Paper for Consideration by ENCWG3

Improvement of ENCs display on ECDIS

Submitted by: ENC Display Sub Working Group (lead: France)

Executive Summary: This paper lists the possible improvements so far identified by the ENC

7. Issue 1 (general): ENC content

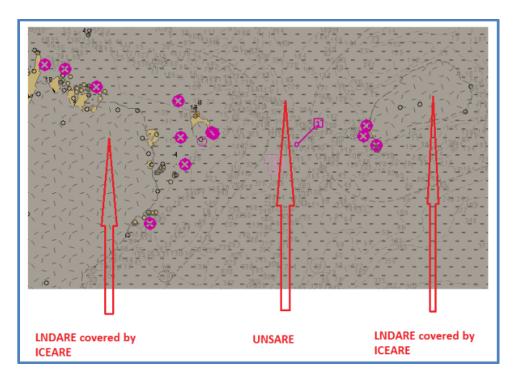
It is globally recognised that ENCs and paper charts, although they have the same purpose (ensure safety of navigation), are definitely two different products. It is also identified that the ENC on screen is often "overcrowded", creating a very poor clarity. ENCs are used on the ECDIS which triggers indications and alarms. This should be taken into account in the way HOs encode dangerous areas in the ENC and the issue is probably more critical at larger scales.

- To avoid screen clutter, the density of information in the ENC should be reduced as compared to what is
 on the paper chart. The former should not be a strict copy of the latter. But this as a possible strong
 impact on the production process (common S-57 database for both products).

- Another option (or additional measure) is probably to adopt a larger scale for the CSCL (Compilation scale = ENC optimum display scale. This is subject to the quality/accuracy of the source data.

- Australia suggests to adopt an "ENC first" scenario rather than the "paper chart first" current approach.
 This is to be taken with Norway's experience: although having the same content, based on the ENC, the paper chart portrayal is often better than the ENC, even when the paper chart is at a smaller scale.

- On the "Production side", there is a need to have an ECDIS view (with display priorities and masking) within the production tools. This would help the cartographer identify cluttered areas.

10. <u>Issue 4: DEPCNT AND SOUNDG ON UNSARE</u>

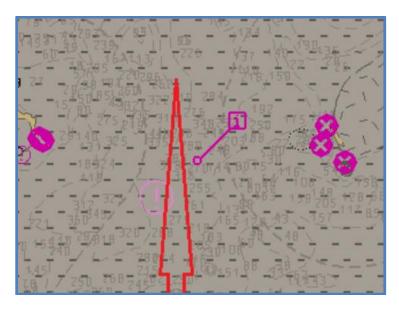
DEPCNT and SOUNDG are hardly visible within UNSARE

$\underline{Possible\ solution} \hbox{: As\ suggested\ in\ UOC\ (\S 5.8.2)\ DEPARE\ objects\ can\ be\ encoded\ with\ a\ CTNARE\ and\ appropriate\ value\ of\ QUAPOS\ on\ bathymetric\ objects.}$

11. <u>Issue 5: UWTROC COVERS LNDARE</u>

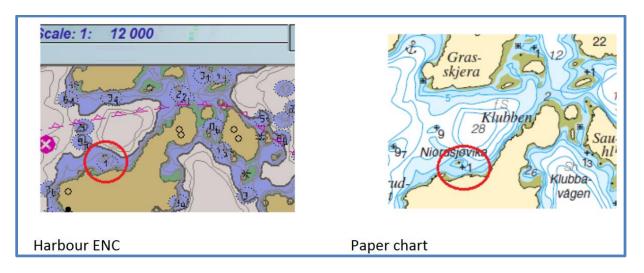
UWTROC symbol covers (hides) point LNDARE (which is a more dangerous feature).

<u>Possible solution</u>: The general opinion of the SubWG is that this is not an encoding issue, but a portrayal one. This is a problem of Display Priority: a feature should never mask a more dangerous one. Although this could only be solved in S-101, the issue is presented here as the display is potentially dangerous for safe navigation. There may be compilation issues. Can't we consider that the UWTROC is "protected" by the LNDARE? Such issues could be passed to the NCWG for advice.

14. <u>Issue 8: LIGHTS_CLUTTER</u>

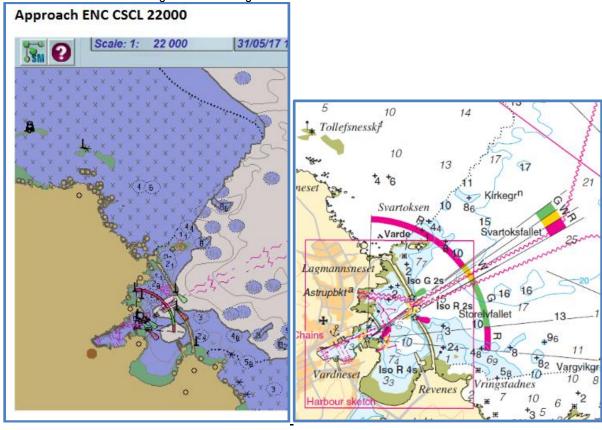
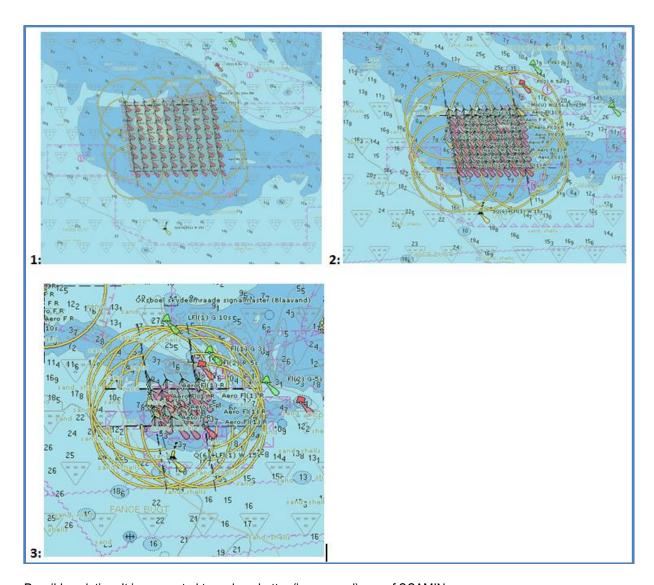
It is difficult to read and distinguish between lights sectors.

Possible solution: It is suggested to make a better (i.e. manual) use of SCAMIN.

15. Issue 9: BUOYAGE DIRECTION SYMBOL

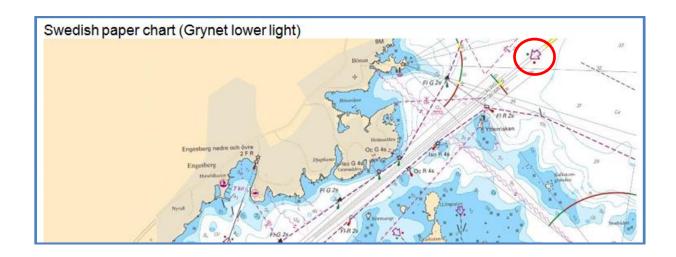
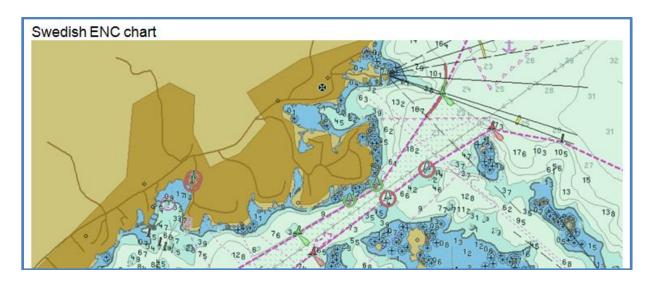
ENC charts are missing the directional buoyage symbol.

Possible solution: Use M_NSYS area object with ORIENT encoded (and mask the limits?).

18. <u>Issue 12: C_AGGR</u>

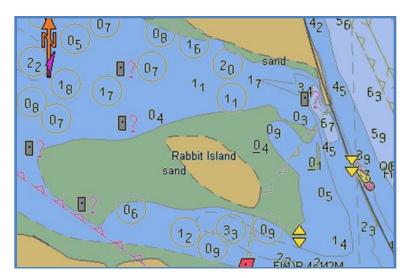
The ECDIS does not highlight objects connected in the C_AGGR, or show which objects are aggregated. Due to this lack (not a failure as regards to the standards), some HOs do not encode C-AGGR.

<u>Possible solution</u>: Suggest that the ENCWG considers the display of a pick report for C_AGGR and C_ASSO as part of any future changes to the S-52 Preslib.
